**Re: 316 Hudson Parade, Clareville – DA2020/1591**

I refer to your letter dated 22 February 2021.

The proposal has been redesigned to address the concerns raised in your letter. The amendments can be summarised as follows:

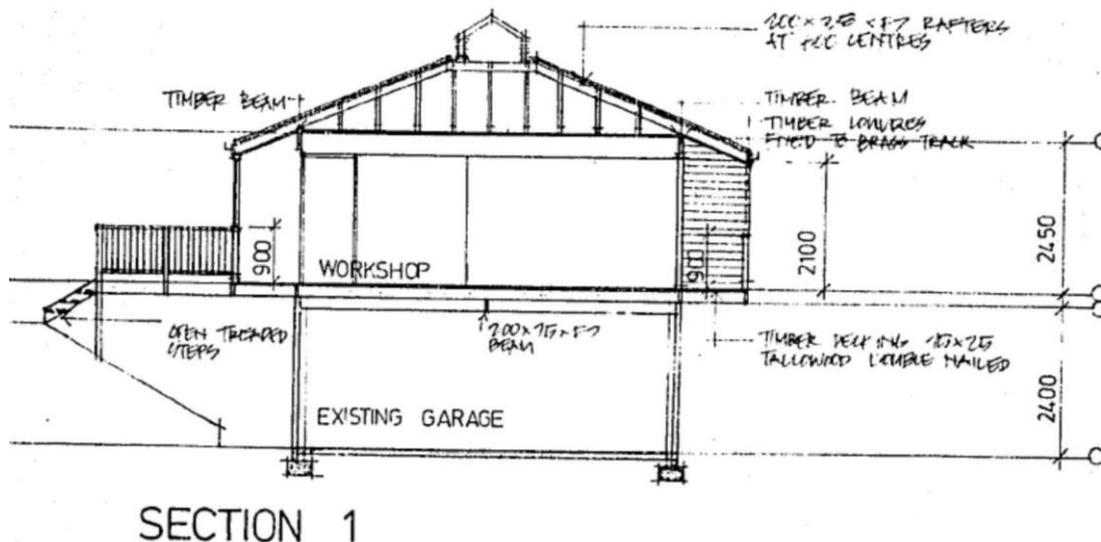
4. A careful analysis of the visual impact of the proposed roof over the master bedroom when viewed from the adjacent waterway has been undertaken. The following photographs show the existing view that is obtained to the subject site from various distances in Pittwater:

*Photograph 1: Close distance view*

*Photograph 2: Medium distance view*

*Photograph 3: Long distance view*

These photographs demonstrate that the dominant elements of the view are the tree canopy and that views of building are filtered. In particular, there is a large

canopy tree located in front of the proposed master bedroom that screens the view of the proposed roof.

The photographs also demonstrate that the subject site is viewed from a position that is substantially below the level of the proposed master bedroom. From this position, whether the roof is a hipped roof or a gabled roof has no visual impact.
